3 H@NC - 60 Eagle Crest Court, Lillington, NC 27546

The Holly - LH 'CRAFTSMAN' ELEVATION

9-26-24 - Redlines - JJ

9-27-24 - Remove Gourmet Kitchen - JJ

FIRST FLOOR PLAN 'CRAFTSMAN'
SCALE: 1/8"=1'-0" ON 11x17, 1/4"=1'-0" ON 22x34

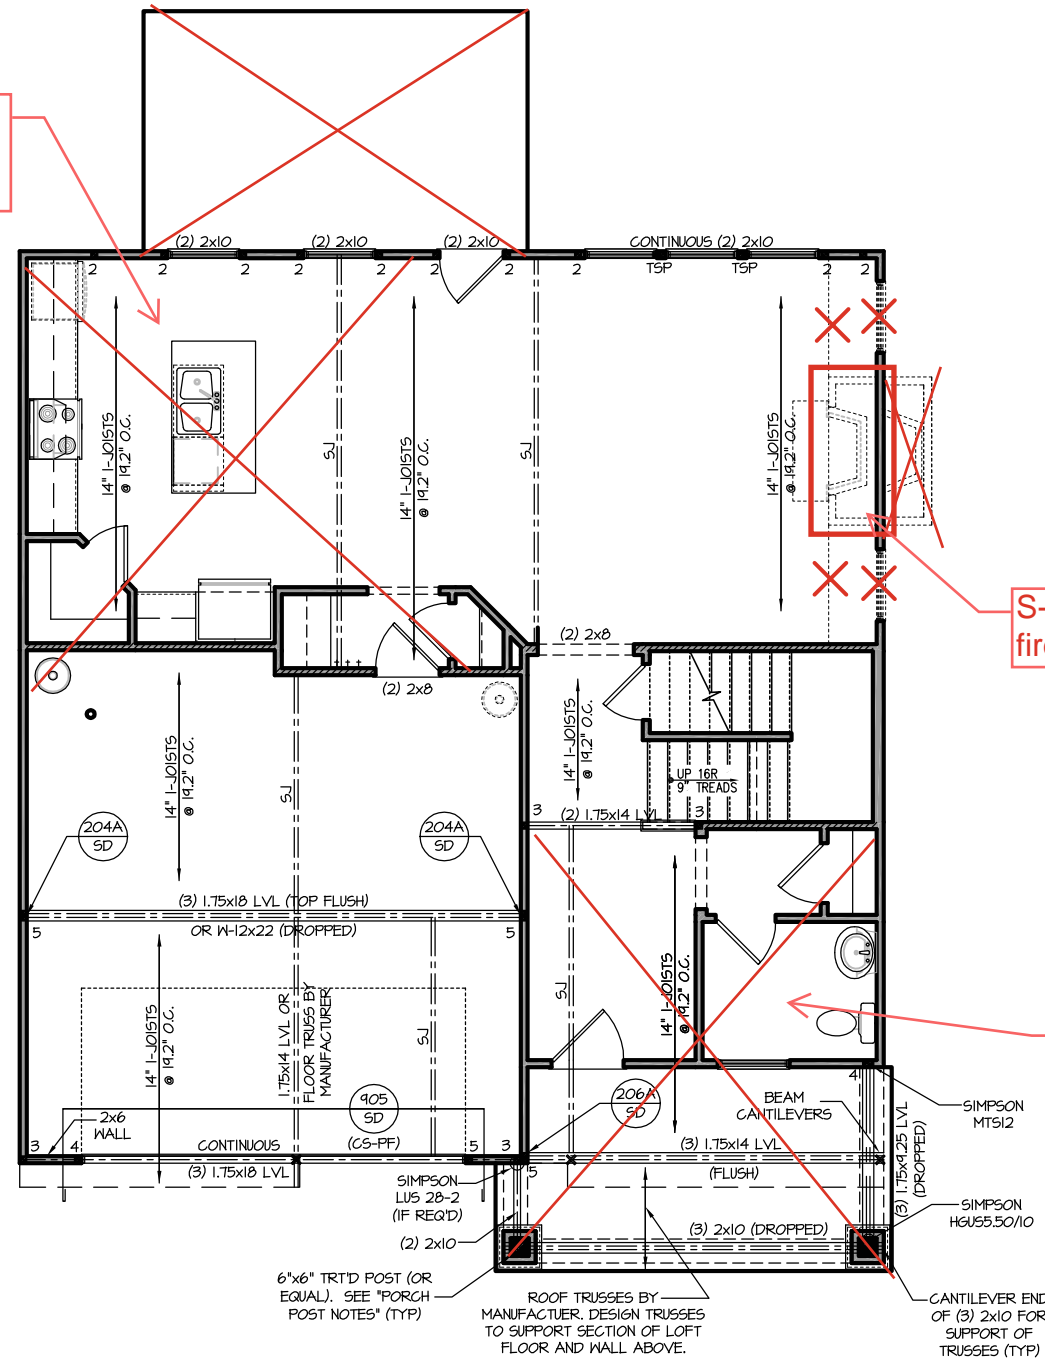
S-2.1.1 for cafe, cov. porch. kitchen & garage change

CRAFTSMAN ROOF PLAN
SCALE: 1/4" = 1'-0" ON 22x34, 1/8" = 1'-0" ON 11x17

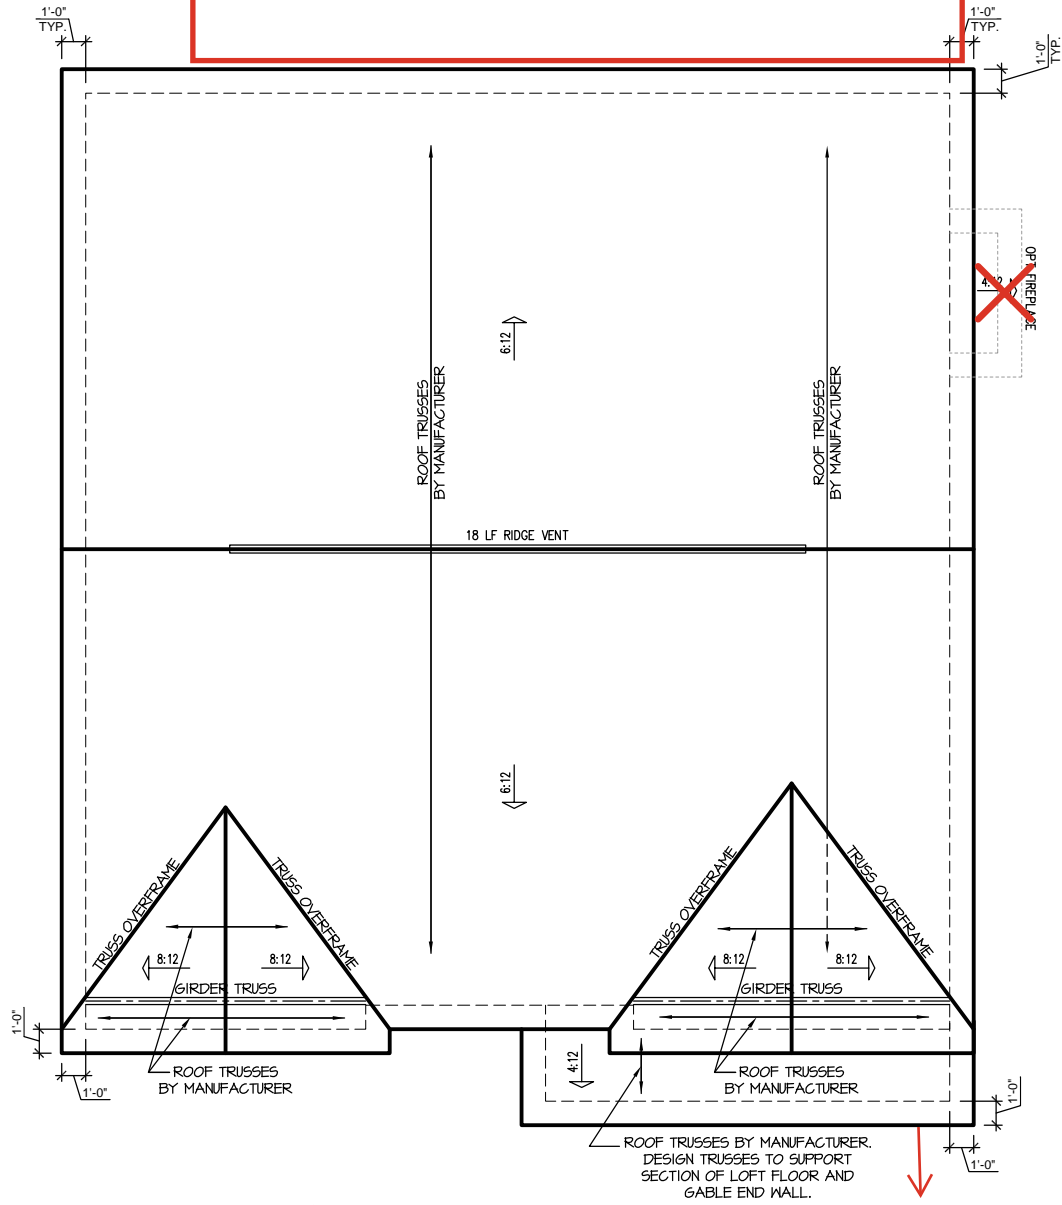
S-2.5.1 for cafe and cov. porch roof
